Product Change Notification

Product Change Notification: P-21-021851

RECEPTACLE/PLUG ASSEMBLY, SOLDER CUP, HD-20, AMPLIMITE

Illustrations of Package Change

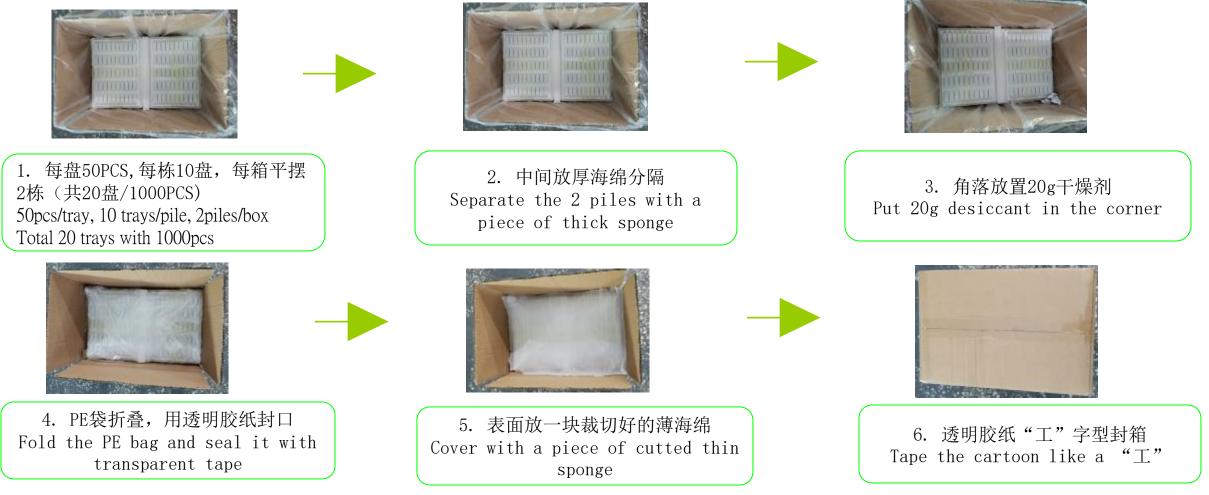
Packaging change in D-sub product: 1. Carton size from 45.5*32*24CM to 35.5*25*19CM. 2. Qty from 2000pcs/ box to 1000pcs/ box, 3. Add PE bag and desiccant in the box. Kindly NOTE: If the full qty of a package is not used in production then the bag needs to be re-sealed with desiccant. Other attachments:

每盘50PCS,平放2栋,每栋12盘,中间 竖放6盘,侧面竖放两排,每排5盘(共40盘 /2000PCS)
 Arrange 2piles by horizontal, 12trays/pile
 Arrange 6 trays by vertical in the middle of this 2 piles.
 Arrange 2 rows by vertical, 5trays/row.
 50pcs/tray, Total 40trays with 2000pcs

2. 用裁切好两块厚海 绵填充 Fill the box with 2pcs of trimmed heavy sponge

3. 表面放一块裁切好的 薄海绵 Cover with a piece of trimmed light sponge

4. 透明胶纸"工"字型 封箱 Tape the cartoon like a "工"

纸箱规格为: 45.5*32*24CM(长*宽*高)

Cartoon spec:45.5*32*24cm(length*width*height)

变更后包装方式Packaging method after change:

纸箱规格为: 35.5*25*19CM(长*宽*高)

Cartoon spec:35.5*25*19cm(length*width*height)
